Review of the Amaila Falls Hydropower Project in Guyana

Final Report

Assignment no.:5164597 Document no.: 1 Version: 1
2016-12-12

Client: NORAD
Client's Contact Person: Knut Gakkestad
Consultant: Norconsult AS, Vestfjordgaten 4, NO-1338 Sandvika
Assignment Manager: Sverre Edvardsson
Technical Advisor: Sverre Edvardsson
Financial Analyst: Frank Isachsen
Environmental Advisor: Kevin Burton

Figure 4 The current design with a natural unit GD^2 , negative stability margins

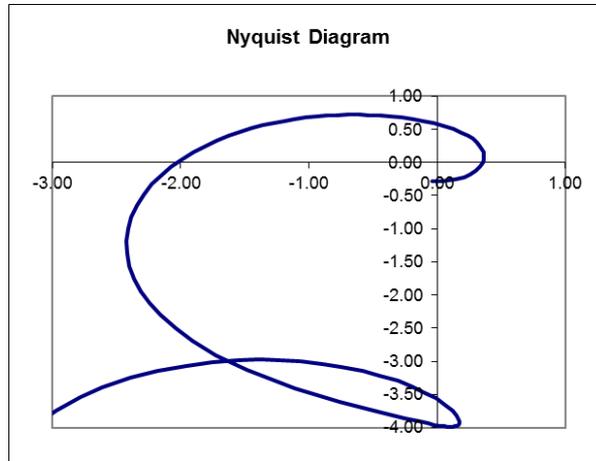
The Nyquist diagram of the system shows negative stability margins, an indication of instability.

Figure 5 The current design with 40% increased unit GD^2 , negative stability margins

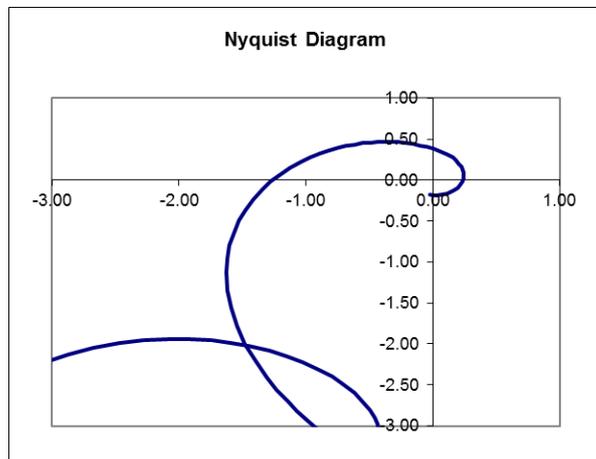
The system is still unstable after an increase of 40% in unit GD^2 .

Figure 6 Natural unit GD2, penstock shortens from about 1540m to 700 m

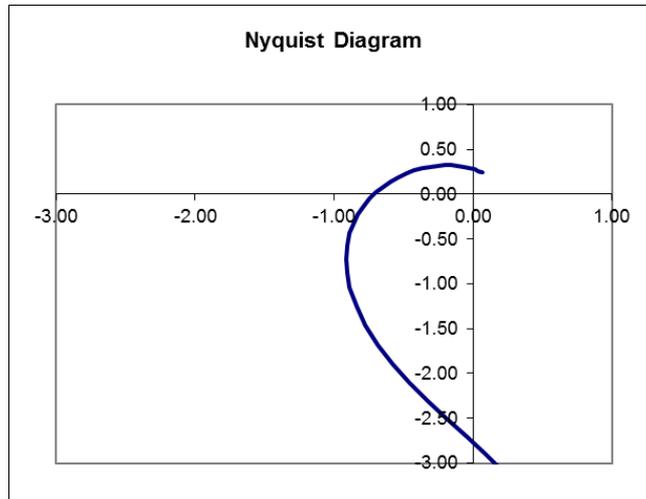
Shortening the length of the penstock can reduce the Tw value of it and thus improve the stability. The total penstock length of the current design is about 1540m. This calculation shows what happens if the total length shortens to 700 m.

The stability margins: Gain margin: 3.0 dB (The stability requirement fulfilled)
 Phase margin: 25.0 degrees (The stability requirement fulfilled)

Figure 7 Unit GD2 increase by 20%, penstock shortens from about 1540m to 830 m

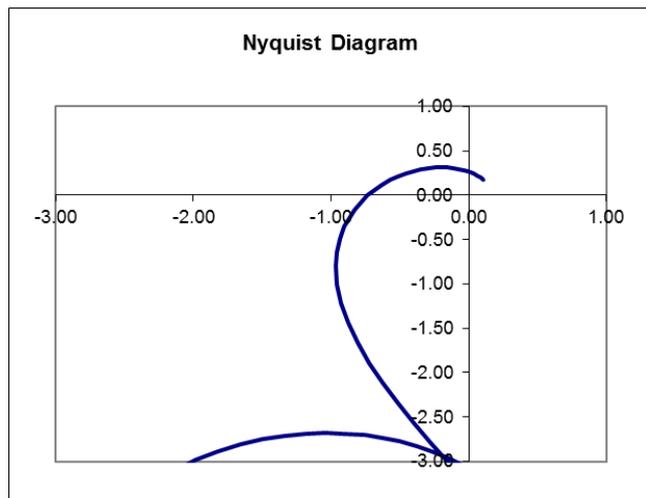
1.5.4 Case 4, pressure shaft shortens to 830m + unit GD² increase by 20%

The stability margins: Gain margin: 3.0 dB (The stability requirement fulfilled)

Phase margin: 26.0 degrees (The stability requirement fulfilled)

Figure 8 Unit GD2 increase by 30%, penstock cross-section doubles

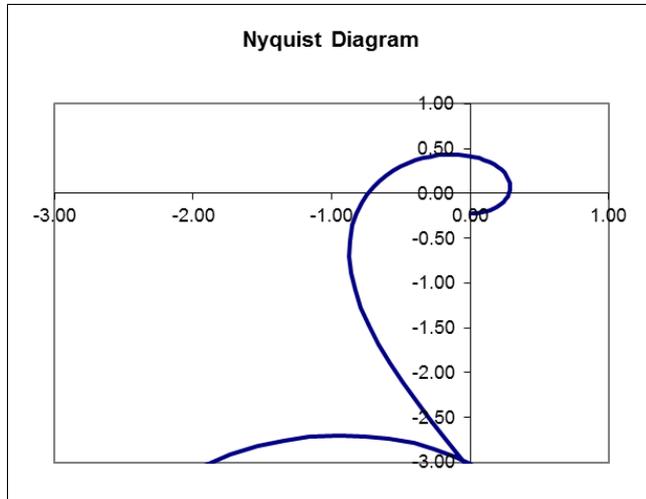
1.5.5 Case 5, Unit GD² increase by 30% + penstock cross-section area increase by 100%

The stability margins: Gain margin: 3.0 dB (The stability requirement fulfilled)
